Path data delay through the n:m SM-PMA

Related to comment #131 against 802.3dj D3.1

IEEE 802.3dj Task Force

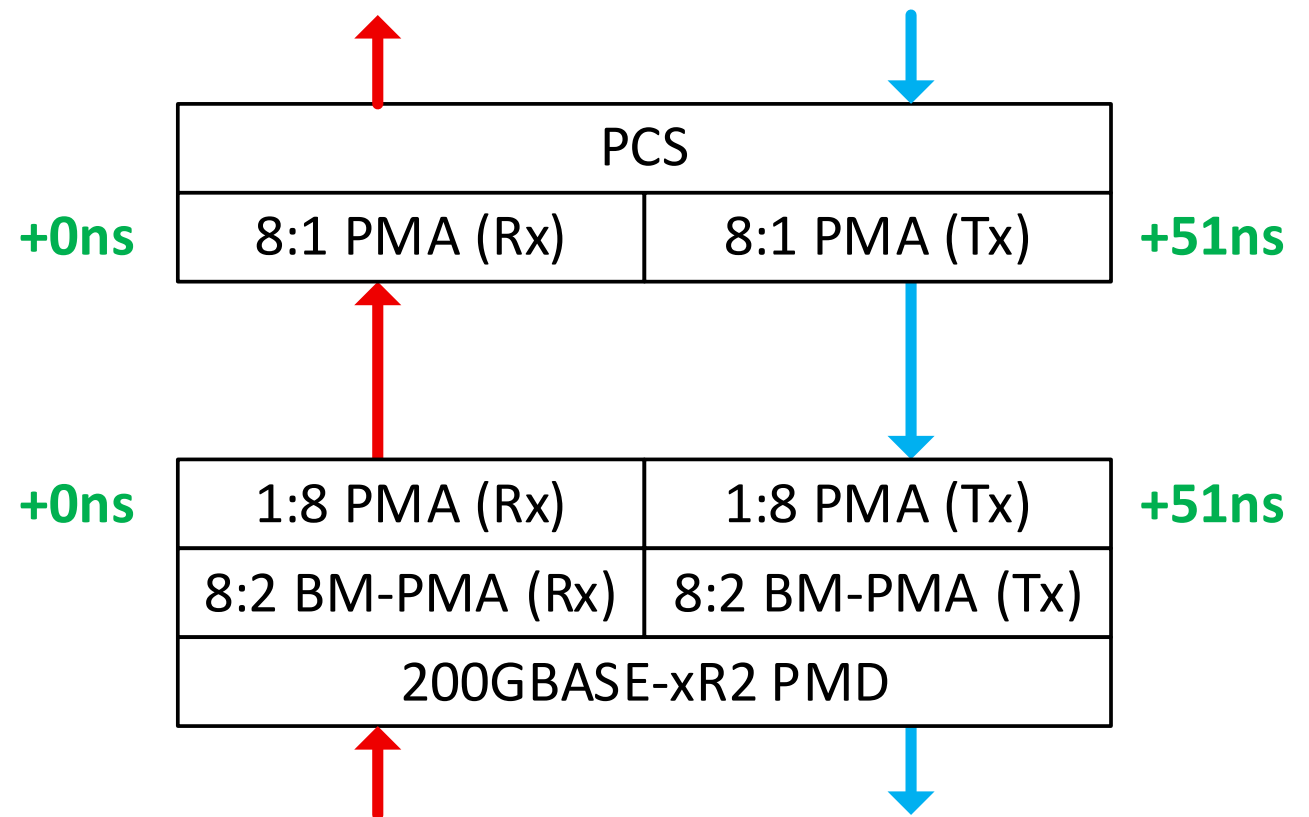
Currently, 176.10 makes no distinction between m:n and n:m PMAs:

The transmit path data delay is reported as the delay incurred by the first bit of the PCS alignment marker of the PCS lane with the largest delay through the PMA. The receive path data delay is reported as the delay incurred by the first bit of the PCS alignment marker of the PCS lane with the smallest delay through the PMA.

BOTH m:n and n:m Tx PMAs report their path data delay with the largest in-to-out PCS lane delay
BOTH m:n and n:m Rx PMA : report their path data delay with the smallest in-to-out PCS lane delay

8:1 PMA Tx path data delay = 51ns

1:8 PMA Tx path data delay = 51ns

Total Tx path data delay = 102ns : 51ns too large!

8:1 PMA Rx path data delay = 0ns

1:8 PMA Rx path data delay = 0ns

Total Rx path data delay = 0ns : 51ns too small!

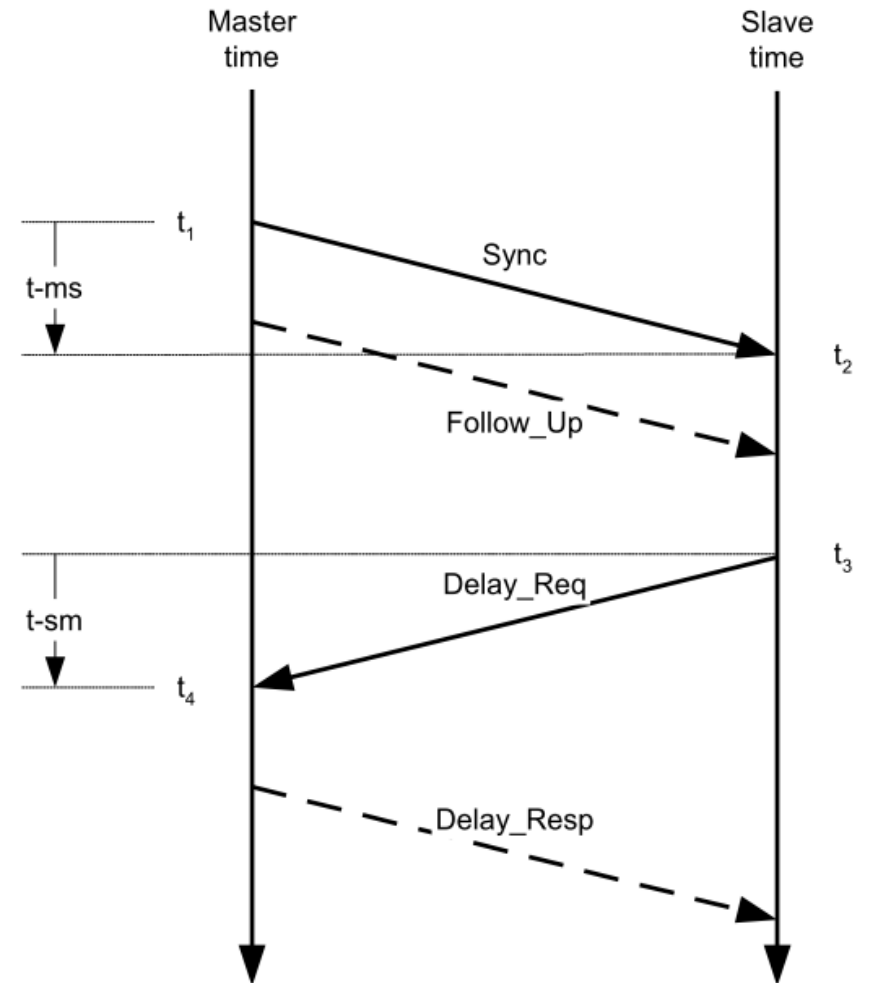
The inaccurate path data delay values look like a link asymmetry, which directly affects time-sync:

If the TimeTransmitter's (master's) PHY reports its path data delay incorrectly:

- t_1 is 51ns too large (Tx MII time + Tx path data delay)
 - **t-ms** appears **smaller** than it should
- t_4 is 51ns too large (Rx MII time - Rx path data delay)
 - **t-sm** appears **larger** than it should

It appears as if the TimeTransmitter (master) is 51ns ahead of the TimeReceiver (slave).

The TimeReceiver (slave) would **erroneously** adjust its Time-of-Day by +51ns!

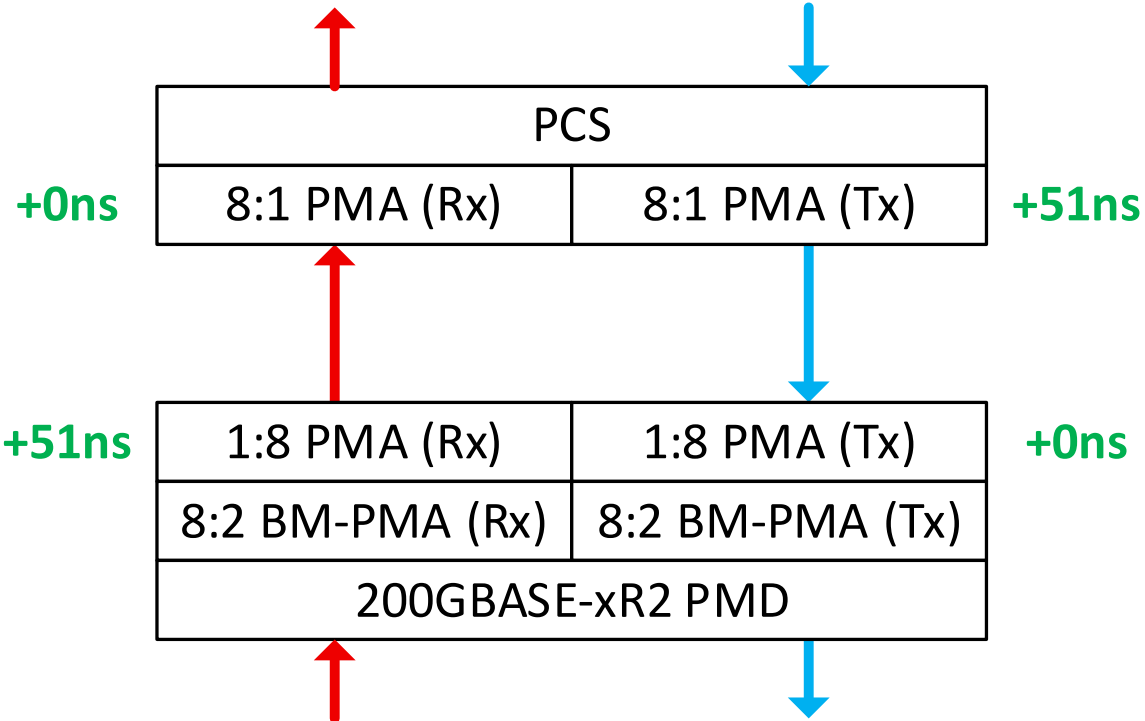
This absolutely needs to be clarified, especially for the PMA_delay status variables for TimeSync. There, the 'Rx' and 'Tx' delays are calculated differently. The delays would be reported incorrectly if approach A were to be used!

In sections 176.5.2, change the sentence to:
The transmit function of the n:m PMAs is identical to the receive function of the m:n PMAs (see 176.4.3), and uses the 'RX' PMA Management variables.

(and a similar update for section 176.5.3)

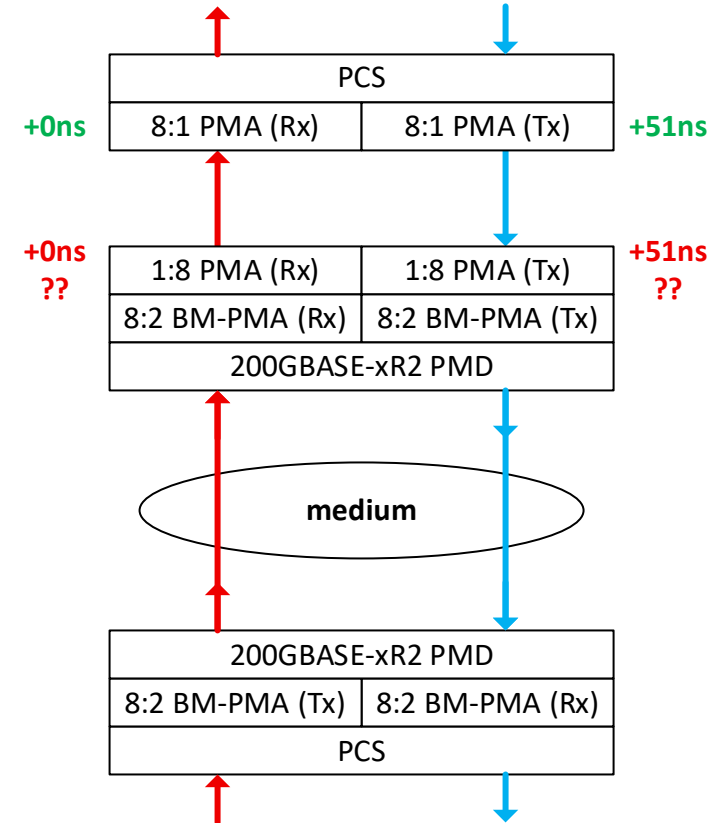
100Gbps/lane PMD where the local PHY has a 200Gbps AUI, and an n:m PMA reporting its path data delays **incorrectly**:

If the PHY with the n:m PMA reports its path data delay incorrectly, the upstream and downstream directions appear asymmetric.
